Freightliner  
Service Bulletin

## General Information

**Fig. 1, A/C Line Installation**

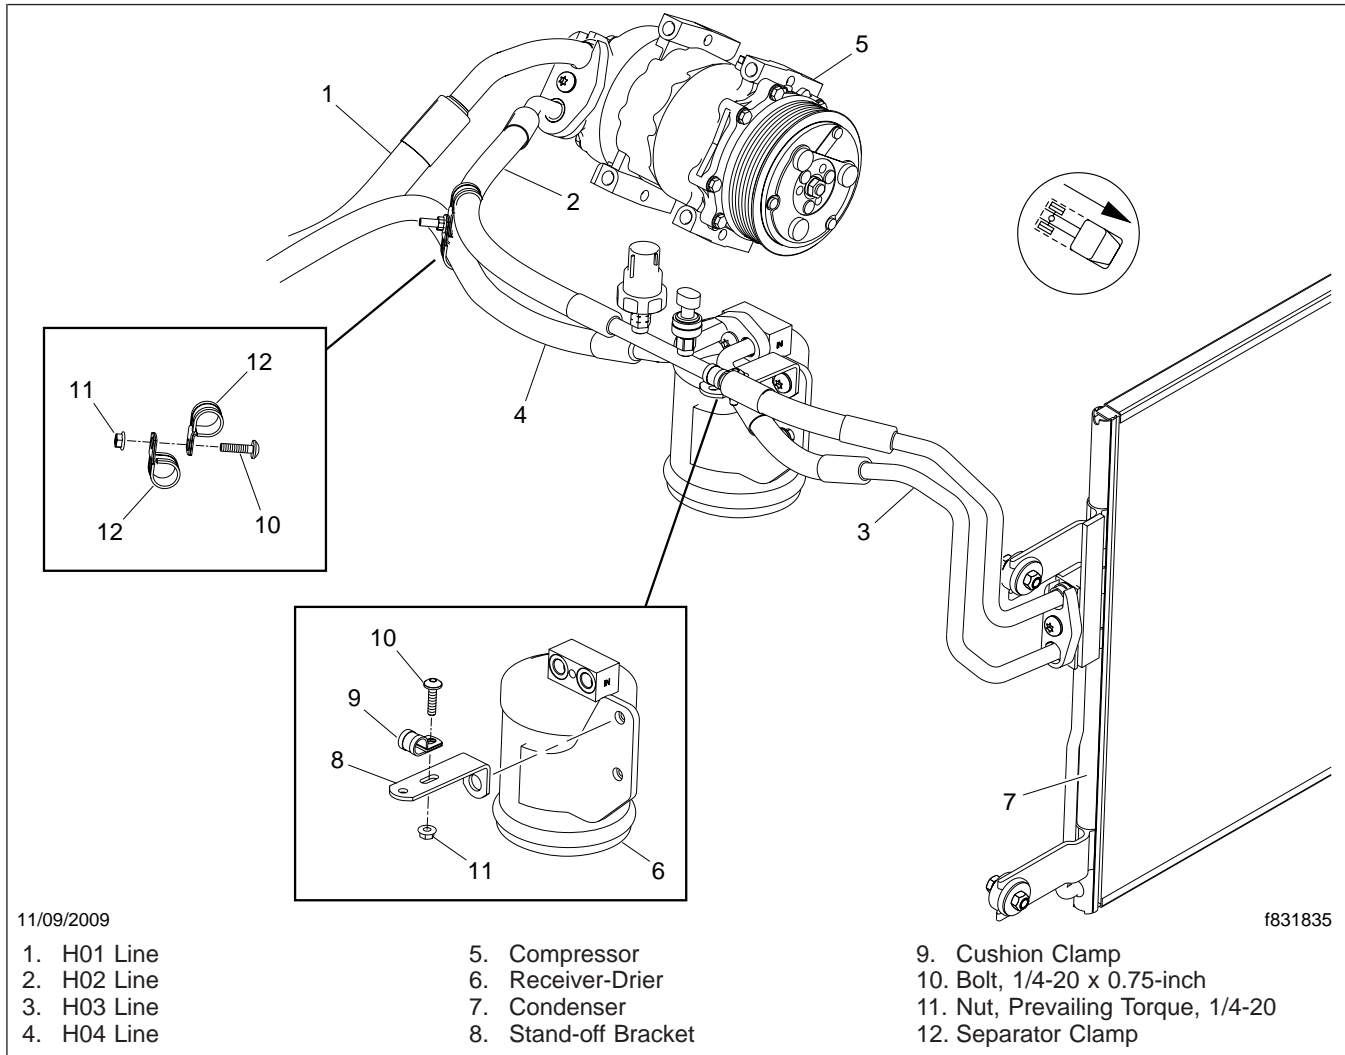
New H02 and H03 lines (in and out of condenser) have been developed, which provide an additional 7/8 to 1-1/8 inch (20 to 30 mm) of clearance to the inside of the hood. The new H02 line also has an added section of flexible hose to help isolate the condenser from engine vibration. If the H02 or H03 hoses have evidence of rubbing on the hood or the condenser has a fracture, the vehicle should be repaired using these updated parts. If a vehicle is being upgraded with the new lines, both H02 and H03 must be replaced as a pair. If subsequent line failures occur, the lines may be replaced individually.

10. Position the new H02 and H03 A/C lines, and using new seals, connect the lines at the compressor, at the condenser and the receiver-drier. Tighten the fasteners on the retaining plates 11 to 15 lbf·ft (15 to 20 N·m). See [Fig. 1](#).

11. Using a cushion clamp, L-shaped stand-off, and hardware listed in [Table 1](#), secure the H02 line to the radiator bracket as shown in [Fig.1](#).
